Appendix I: Stage 1 Road Safety Audit (RSA) 1 (June 2025)

Navigator Quarter

Stage 1 Road Safety Audit

Ref: 3117-RSA-01 A

Problem Location Plan

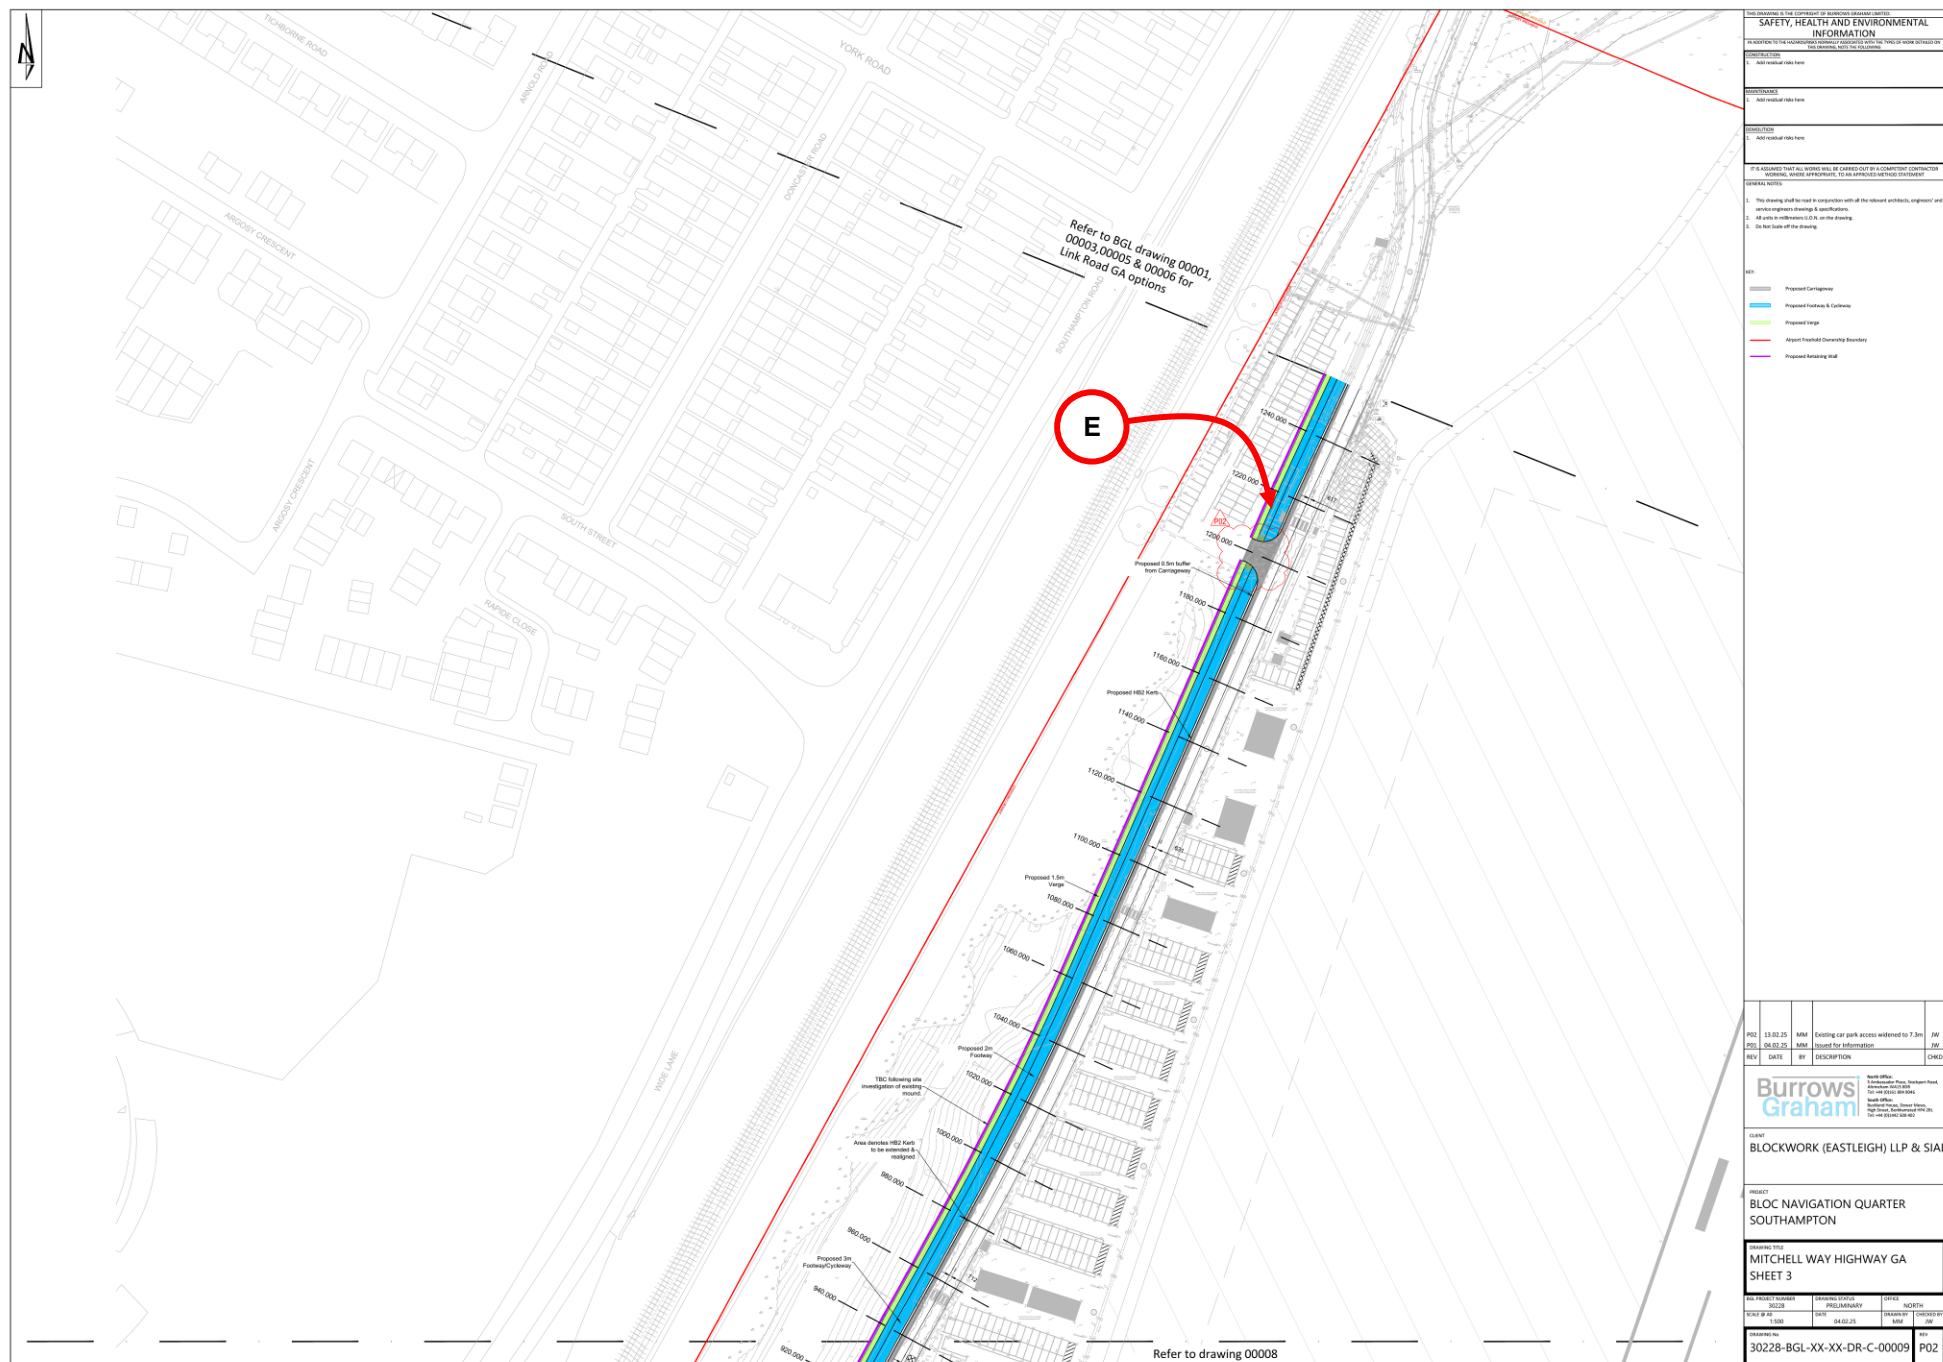
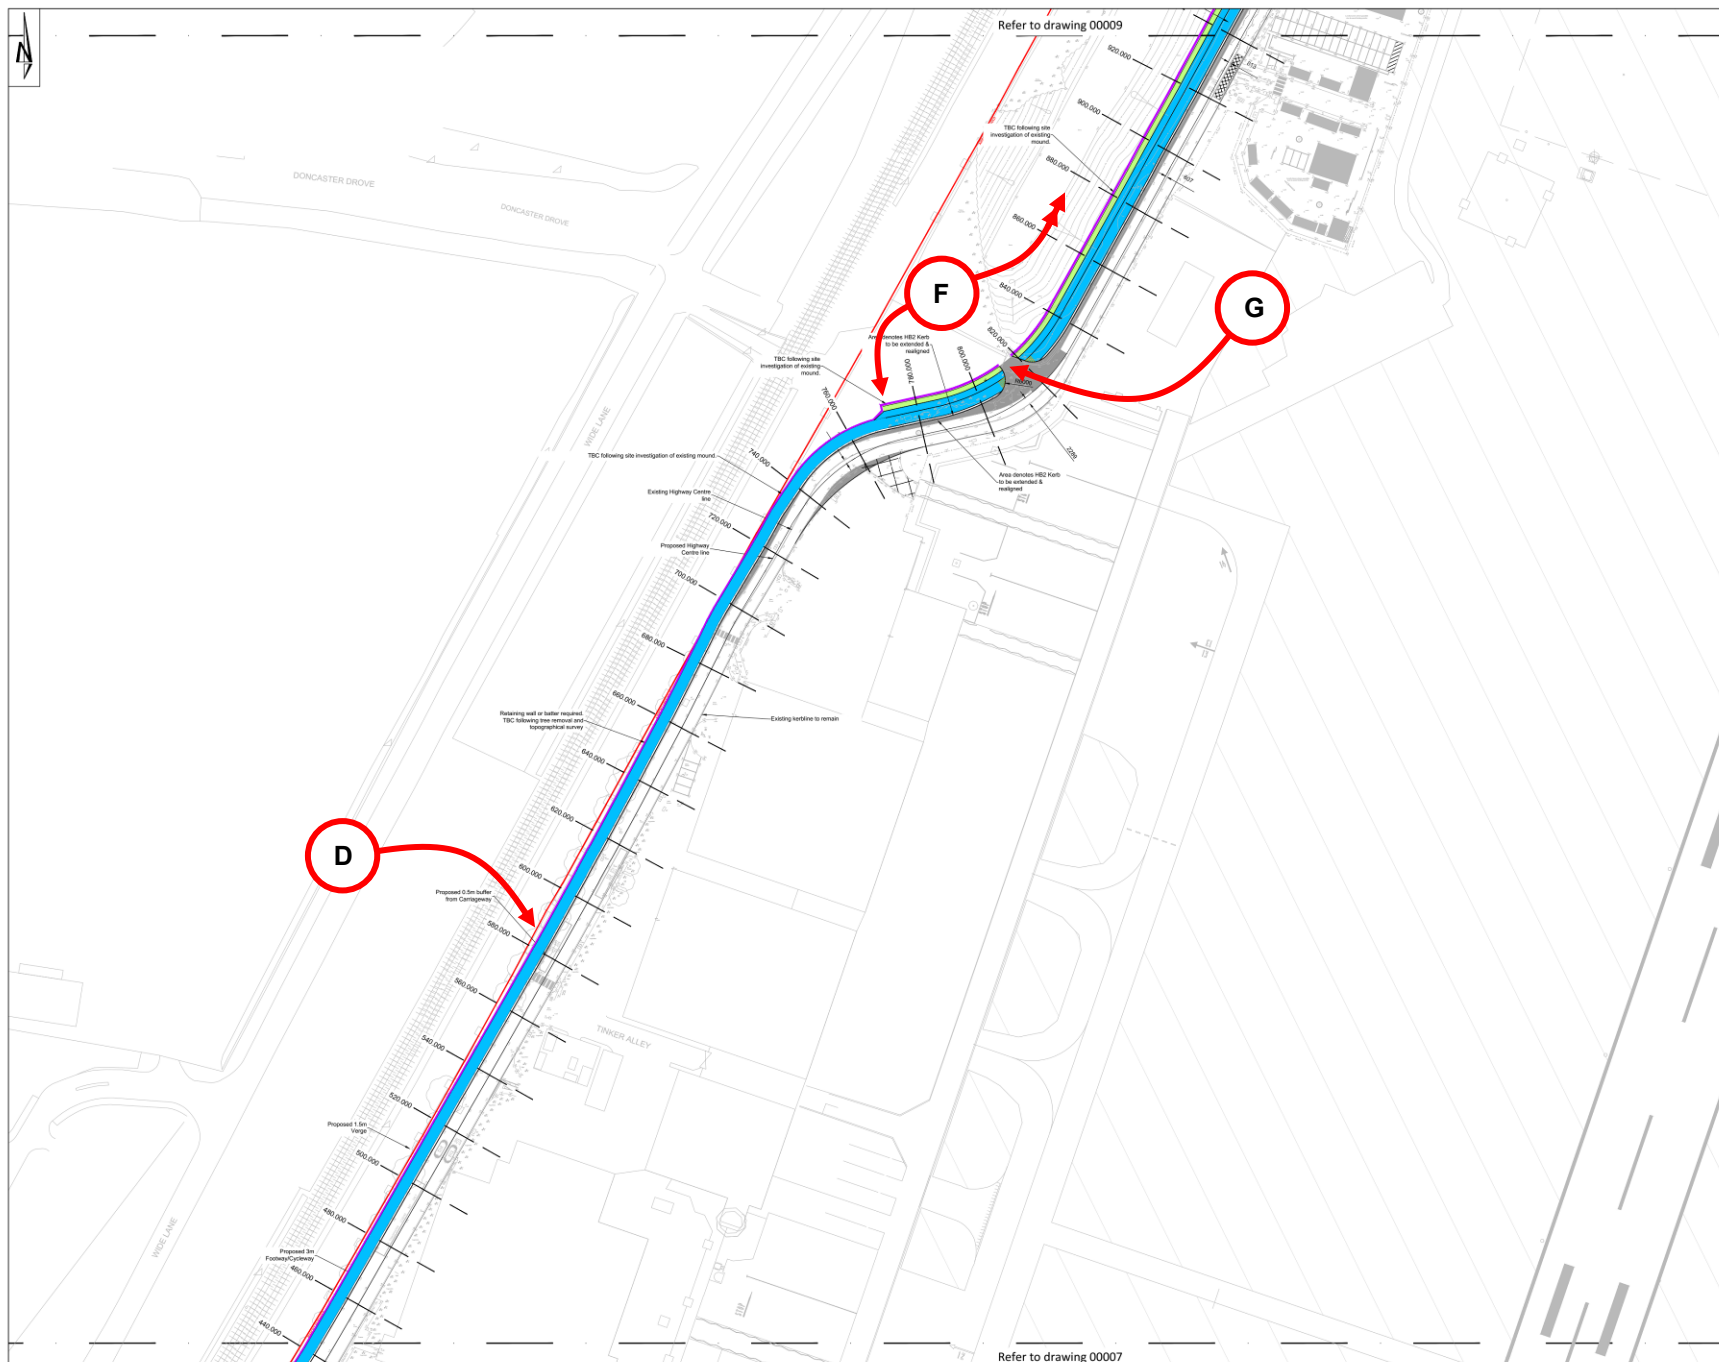
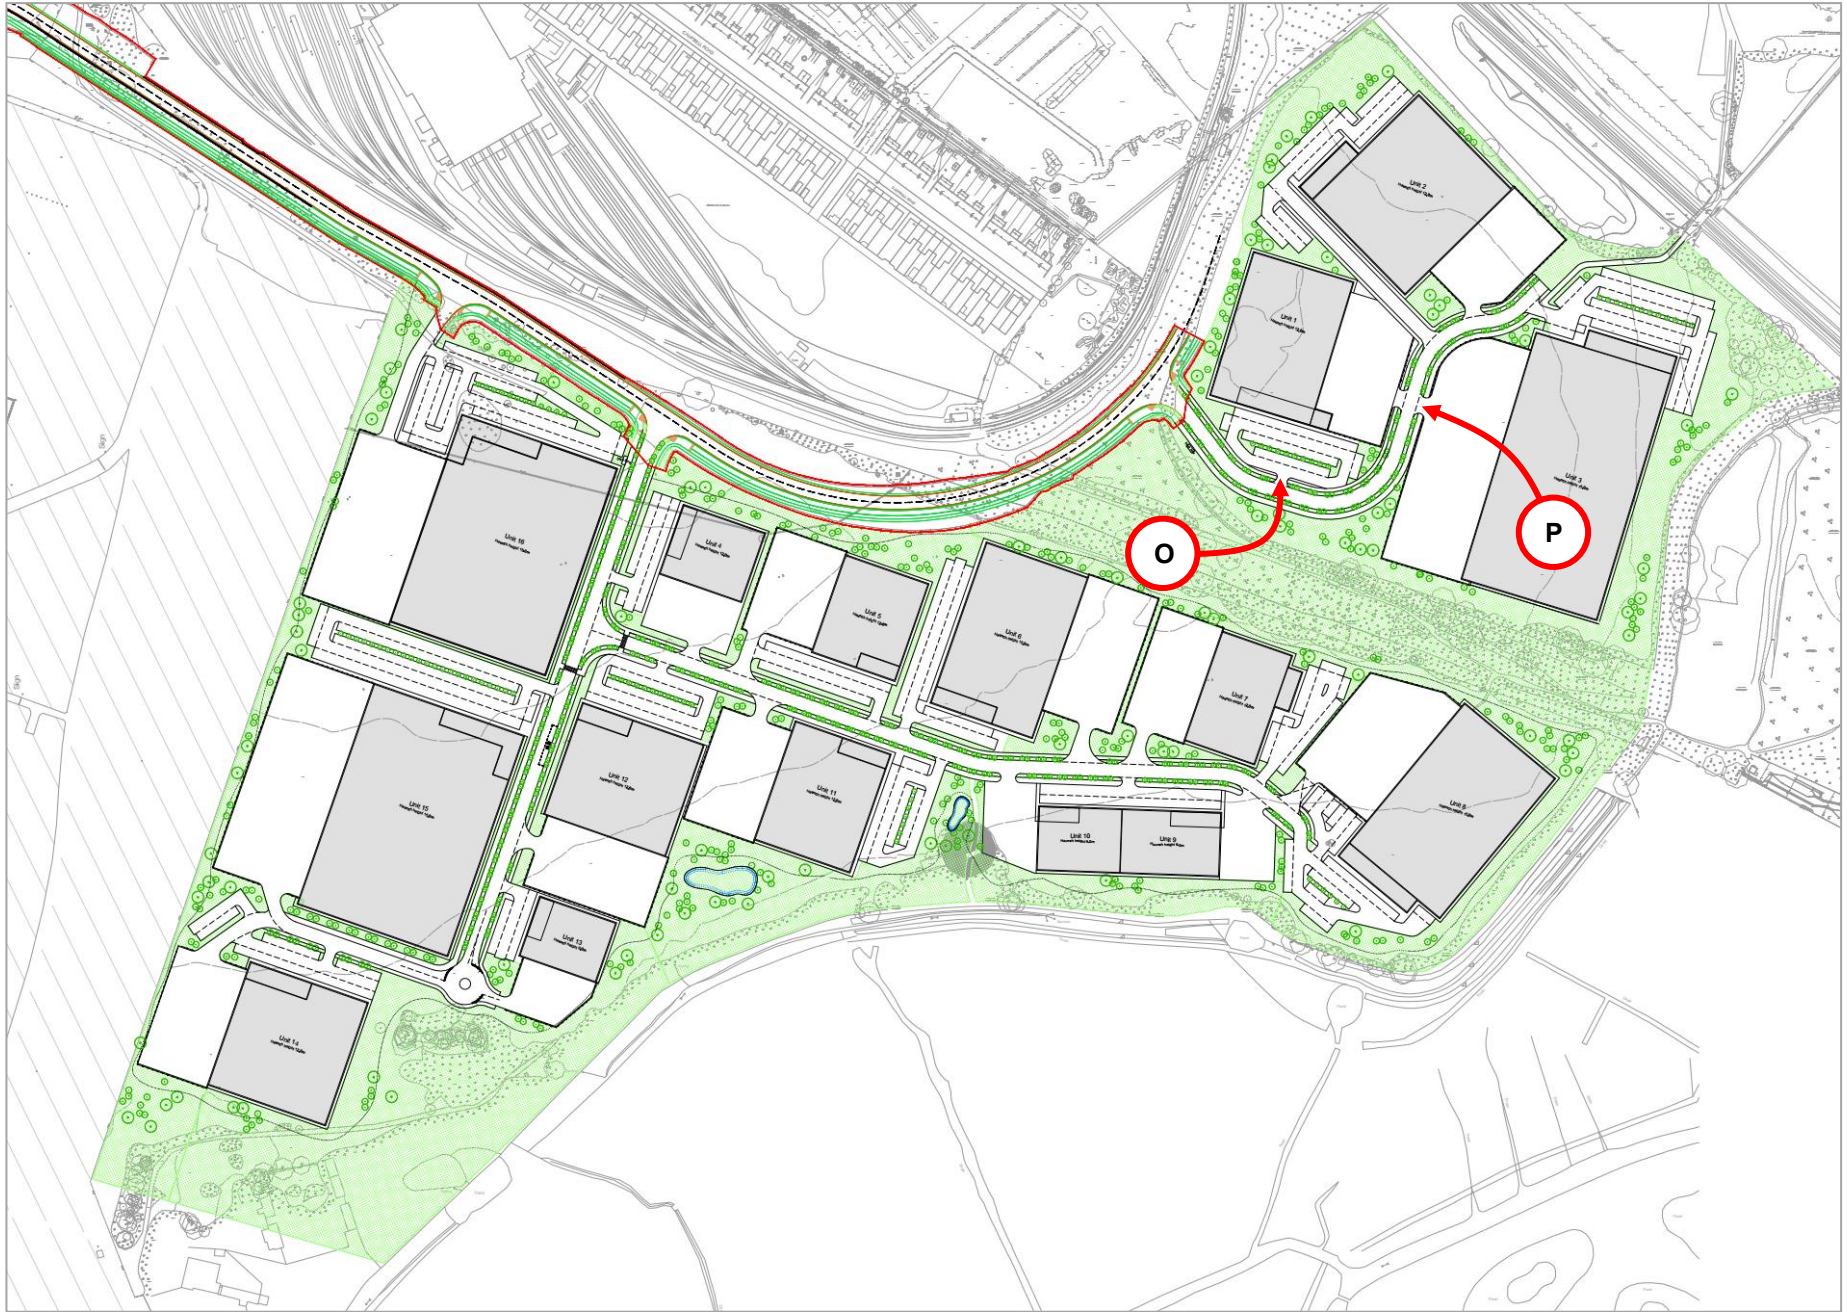
Location: A – Unsegregated shared use footway by the railway station.

Summary: Risk of collisions between pedestrians and cyclists.

The shared-use footway will commence by the railway station and proceed northwards along Mitchell Way to the development sites. It will predominantly be a segregated surface for pedestrians (2.0m) and cyclists (3.0m) plus a buffer zone (0.5m). However, the southern section through to Chainage 770m will be an unsegregated, 3.0m wide surface. Particularly by the railway station and the Zebra crossing at Chainage 300m, a significant route between the station and airport terminal, this may be too narrow. In this location there can be a higher volume of pedestrian movements, especially on the arrival of a train. This volume of movements may increase the risk of collisions between pedestrians and passing cyclists. The situation may be exacerbated by the retention of extensive pedestrian guardrails fronting the station, presumably installed to deter drop-off activity. This reduces the available footway width by the set back from the carriageway and by the front edge of the footway being bounded by a vertical feature.

A wider shared footway surface should be provided fronting the railway station, especially around the Zebra crossing at Chainage 300m.

Location: B – Proposed shared-use surface by the railway station.

Summary: Significant items of street furniture may be difficult to relocate.

The location of significant items of street furniture should be confirmed prior to any design freeze of the proposed alignment to ensure that they can be adequately accommodated.

Location: C – Proposed shared-use surface by the railway station.

Beryl Bike bays of appropriate capacity should be conveniently located by the railway station.

Location: D & E – Bus stops, Chainage 580m and 1200m.

If the bus stops with their shelters are to be retained, the shelters should be properly incorporated into the proposed layout, e.g. set back off the main footway surface and with open fronts to maintain good visibility.

Location: F – Existing Zebra crossings beyond Chainage 770m.

If the crossings are to be retained, there should be short sections of unsegregated footway surface around the crossing point, complete with ladder/tramline tactile paving and Diag. 956/957 signs.

Location: G – Rosewood compound, Chainage 820m.

Access to the compound should be reconfigured such that vehicles do not dwell across the footway whilst the gates are being opened or closed.

Location: H – NMU crossing, Chainage 40m.

A Parallel crossing should be provided so that pedestrians or cyclists can assert precedence over motor vehicles to cross. The crossing should also be lit.

Location: I – Long stay car park access, Chainage 160m.

The car park access should be realigned to achieve a minimum angle of 70 degrees with the spine road / Mitchell Way. It should also be verified that adequate visibility is available at the junction.

Location: J – Retaining walls and covered footway, across the top of the airfield.

Parapet rails should be installed along the tops of the retaining walls, with the rail height appropriate for the type of users, i.e. 1.1m where there are only likely to be pedestrians, or 1.4m where there may be cyclists present. Care should be taken to maintain the indicated footway design widths, clear of obstructions such as parapet rails or covered footway posts. The start points of the retaining walls,

Location: K – Carriageway alignment between Chainage 550m and 650m.

The alignment should be smoothed and straightened.

Location: L – Priority junction, Chainage 740m.

The crossing points should be moved further into the bellmouth, where the crossing distance is less and it can be easier to judge if a vehicle is turning from the major road onto the minor road.

Location: M – Spine road alignment beyond Chainage 770m.

Adequate stopping sight distance should be shown to be available around the full extent of the bend.

Location: N – Priority junction, Chainage 1040m.

If swept paths allow, a refuge island should be added to make the crossing two stage. Otherwise, the crossing points should be moved further into the bellmouth, where the crossing distance is less and it can be easier to judge if a vehicle is turning from the major road onto the minor road.

Location: O – Unit 1 car park.

Adequate visibility should be available at the access.

Location: P – Unit 1 & Unit 3 accesses.

The accesses should be staggered.

Design Organisation Response	Partially Accepted
Burrows Graham:	-
Michael Sparks Associates:	-
Steer:	The site is constrained by land ownership and the station therefore it is not feasible to widen the footway any further. Removal of guard rail and decluttering of street furniture will however be considered at detailed design to maximise the available width.
Client Organisation Comments	
Agree with Design Organisations' Response.

Design Organisation Response	Accepted
Burrows Graham:	This will be considered further at detailed design stage, aiming to maximise highway width to limit any removal of existing street furniture/signage etc.
Michael Sparks Associates:	-
Steer:	Removal/relocation and decluttering of street furniture will be considered at detailed design to maximise the available width.
Client Organisation Comments	
Agree with Design Organisations' Response.

Design Organisation Response	Accepted
Burrows Graham:	-
Michael Sparks Associates:	-
Steer:	It is noted that there is already a Beryl Bike area provided at the station, on the northwest side of the tracks, therefore no further changes are considered necessary.

Design Organisation Response	Accepted
Burrows Graham:	-
Michael Sparks Associates:	-
Steer:	The northbound bus stop is an airport stop for their shuttle bus. Land is constrained at this location,

Design Organisation Response	Accepted
Burrows Graham:	-
Michael Sparks Associates:	-
Steer:	This will be picked up as part of the detailed design, with shared use areas/tramline tactile paving and appropriate signage provided as required.

Design Organisation Response	Partially Accepted
Burrows Graham:	-
Michael Sparks Associates:	-
Steer:	This access is gated and infrequently used, therefore the likelihood of conflict here will be minimal and infrequent. We will however review further in detailed design and potentially explore tightening up the junction/reinstating as a continuous footway treatment across the access to give better priority to pedestrians/cyclists across the access.

Design Organisation Response	Partially Accepted
Burrows Graham:	This is something that will be picked up by Hoare Lee at detailed design stage.
Michael Sparks Associates:	-
Steer:	This will be reviewed further as part of the detailed design, and a street lighting design will also be undertaken and will ensure the crossing is adequately lit.
Client Organisation Comments	
Agree with Design Organisations' Response.

Design Organisation Response	Partially Accepted
Burrows Graham:	It is noted that this car park is not in use at present, however the concerns are noted. Further options can be explored during the detailed design stage as required (dependent on any expected future usage of

Design Organisation Response	Accepted
Burrows Graham:	VRS & other safety barriers will be considered at detail design stage. This may result in a slight realignment of the highway to accommodate any physical features.
Michael Sparks Associates:	-
Steer:	-
Client Organisation Comments	
Agree with Design Organisations' Response.

Burrows Graham:	This was designed in relation to green space requirements to the south of the road, north of the proposed development, to provide the required space & stay within Land ownership boundaries & adhere to SGN requirements for Gas Main. This has however been revisited and the alignment amended to straighten it out.
Michael Sparks Associates:	-
Steer:	-
Client Organisation Comments	
Agree with Design Organisations' Response.

Design Organisation Response	Accepted
Burrows Graham:	Crossing points have been amended to suit auditor's recommendations.
Michael Sparks Associates:	-
Steer:	-
Client Organisation Comments	
Agree with Design Organisations' Response.

Design Organisation Response	Accepted
Burrows Graham:	Visibility splay has been checked which follows the back of the verge, the existing levels are such that this doesn't interfere with the visibility splay to allow clear visibility.
Michael Sparks Associates:	-
Steer:	-
Client Organisation Comments	
Agree with Design Organisations' Response.

Design Organisation Response	Accepted
Burrows Graham:	A pedestrian refuge island is not feasible, however the

crossing has been moved further into the bellmouth.
Michael Sparks Associates:	-
Steer:	-
Client Organisation Comments	
Agree with Design Organisations' Response.

Design Organisation Response	Accepted
Burrows Graham:	-
Michael Sparks Associates:	-
Steer:	As these Units and sections of roads are in outline this will be dealt with at Reserved Matter stage, where low-level planting will be explored.
Client Organisation Comments	
Agree with Design Organisations’ Response.

Design Organisation Response	Partially Accepted
Burrows Graham:	-
Michael Sparks Associates:	-
Steer:	As these Units and sections of roads are in outline this will be dealt with at Reserved Matter stage.
Client Organisation Comments	
Agree with Design Organisations’ Response.
